SUBJECT: Pantex Fire Protection Program

February 12, 2024

Staff Report

Review of the Pantex Plant Fire Protection Program

Figure 1. Comparison of Short-Term and Long-Term Impairments

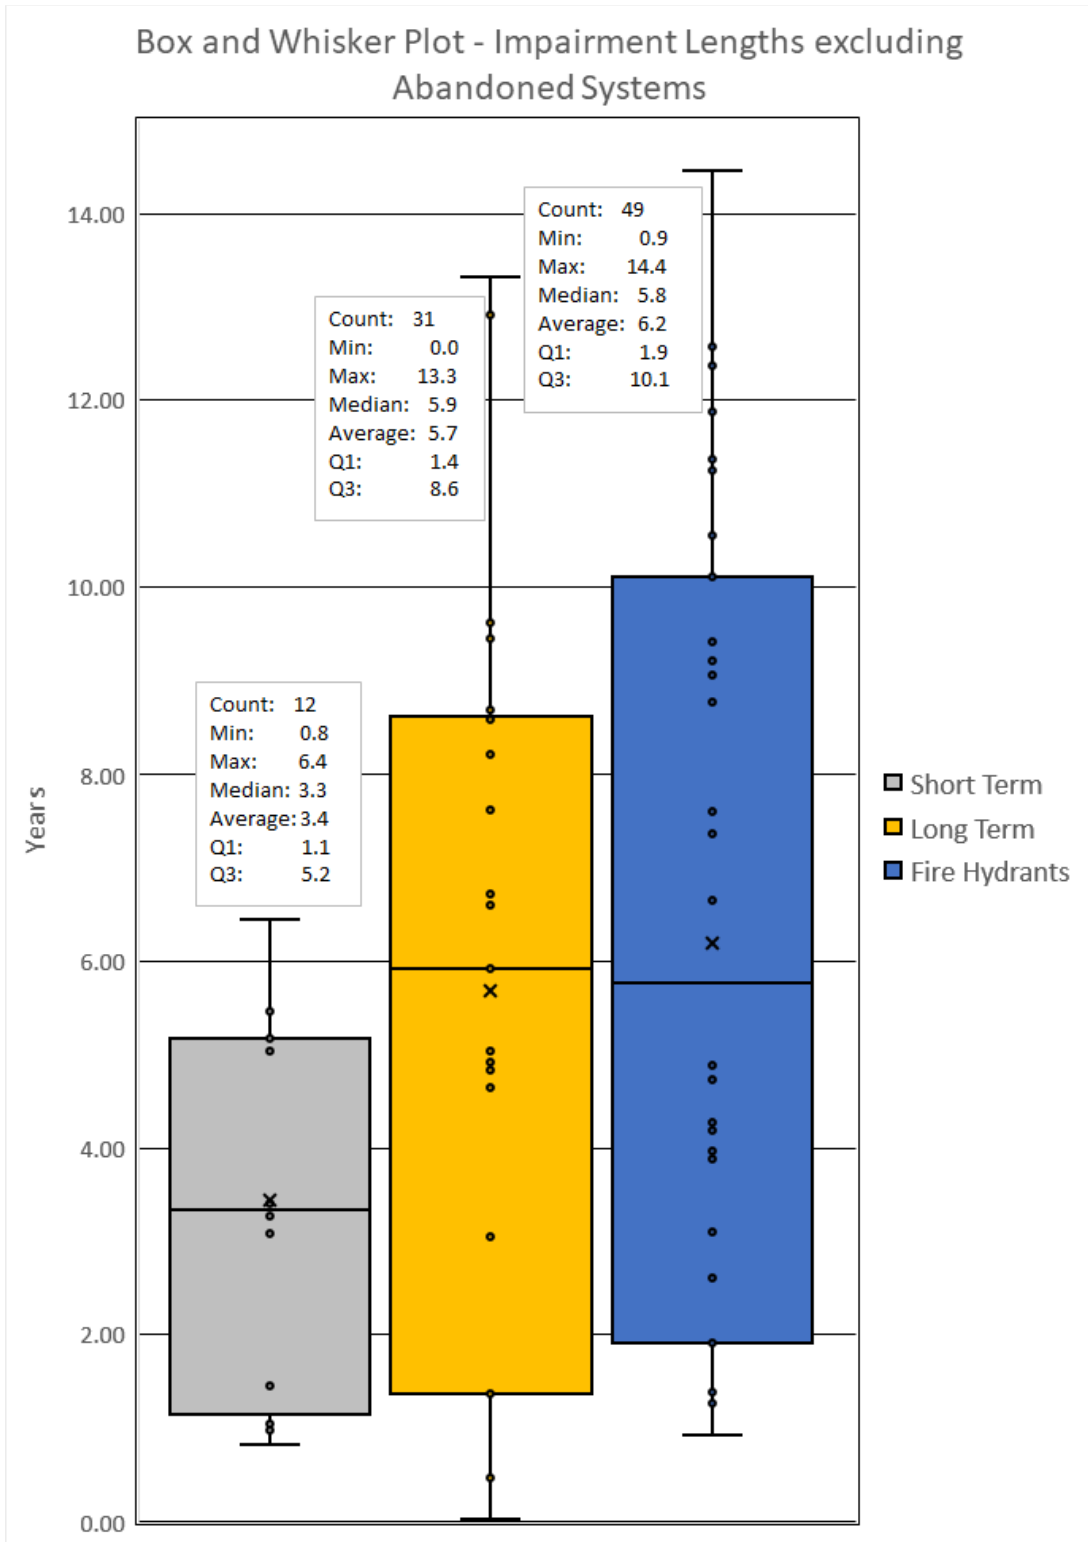
In addition to delays in notifying ESDC, the current impairment data categorization is not conducive to prioritize repairs. For example, there is little differentiation between short-term and long-term impairments, which can be used as a part of prioritization. Figure 1 shows the length of impairments in the short-term, long-term, and fire hydrant categories from Pantex impairment data. As seen in Figure 1, there is significant overlap in the length of impairments considered "short-term" and "long-term." The fire hydrant category in the figure demonstrates that these impairments could be considered either short- or long-term.

Poor categorization of impairments can hamper proper prioritization of repairs to impaired systems. CNS stated that a part of the new effort to track impairments will include redefining what constitutes a short- or long-term impairment, as well as additional categorization. CNS has already made some improvements to impairment data categorization, such as removing abandoned systems from the long-term category. The staff review team agrees with this approach and considers that additional study of impairment data categorization could further improve prioritization of repairs.

Figure 2. *Categorization of Preventive Maintenance in Monthly Metric Report [2]*

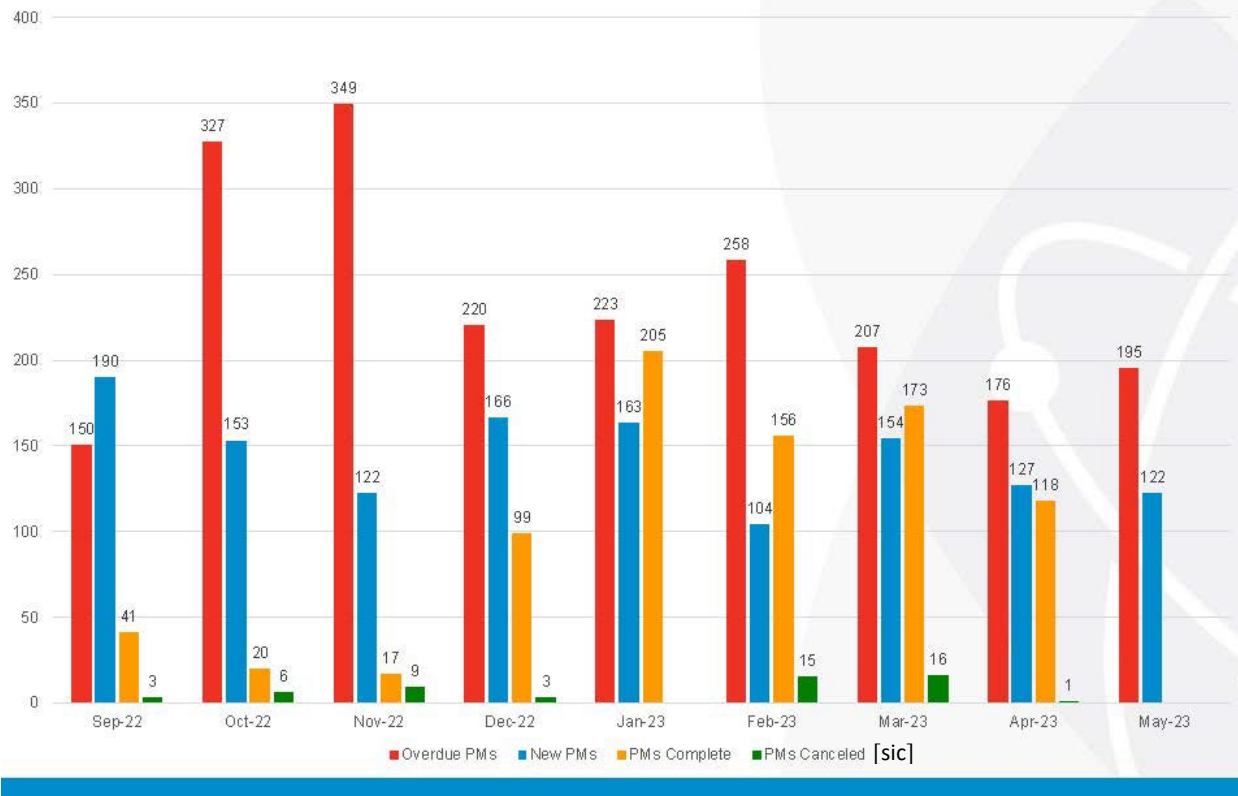
Confusing Presentation of Metrics for Preventive Maintenance (PM)—The monthly report of fire protection metrics notes fire system PM activity in terms of “Overdue PMs,” “New PMs,” “Completed PMs,” and “Cancelled PMs.” Figure 2 shows an example of the presentation of monthly PM metrics.

As suggested by the category title “Cancelled PMs,” it appears that CNS cancelled fire protection maintenance activities on a regular basis. CNS clarified that the category of “Cancelled PMs” in the Pantex site fire protection maintenance data consists of two subcategories:

CNS stated that most, if not all, “Cancelled PMs” fall into the first category, and that no systems in defense nuclear facilities fell into the second category. While the staff review team now understands this nuance, CNS should consider revising the presentation of PM data in the monthly metric report to more clearly depict how many PMs are cancelled and not performed.
